DS28E02 ERRATA SHEET

Revision A1 Errata

1) INITIAL SLOW POWER RAMP RESULTS IN FASTER 1-Wire TIMING

Figure 1. Initialization Sequence Waveform

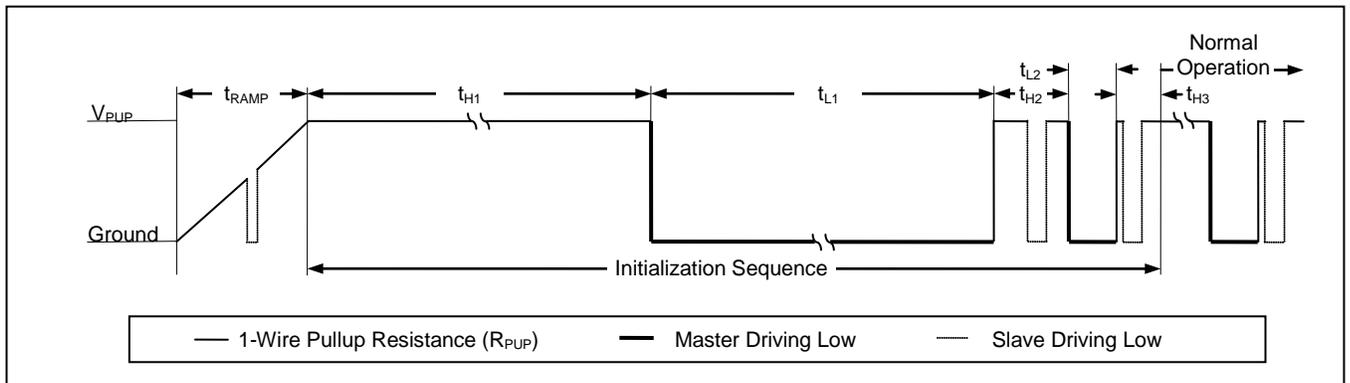
During power-on reset, a trim value is copied from an EEPROM location to the circuit that controls the DS28E02's timing. If t_{RAMP} is too long, the copy takes place before the EEPROM has reached its internal operating voltage. As a consequence, incorrect data is copied to the timing circuit, which in turn cannot operate within data sheet limits. This causes the 1-Wire Master to miss presence pulses or to read a logic 1 instead of a logic 0.

For all t_{RAMP} cases, the incorrect timing is prevented if, after power-up, the 1-Wire master performs the initialization sequence (t_{H1} , t_{L1} , t_{H2} , t_{L2} , t_{H3}) as shown in Table 1 and Figure 1. The t_{L1} segment forces a power-on reset of the DS28E02, which completes during t_{H2} . The fast rise time at the end of t_{L1} ensures proper loading of the trim value and accurate timing.

Further, always start 1-Wire communication with a reset/presence detect sequence before issuing a 1-Wire ROM function command.
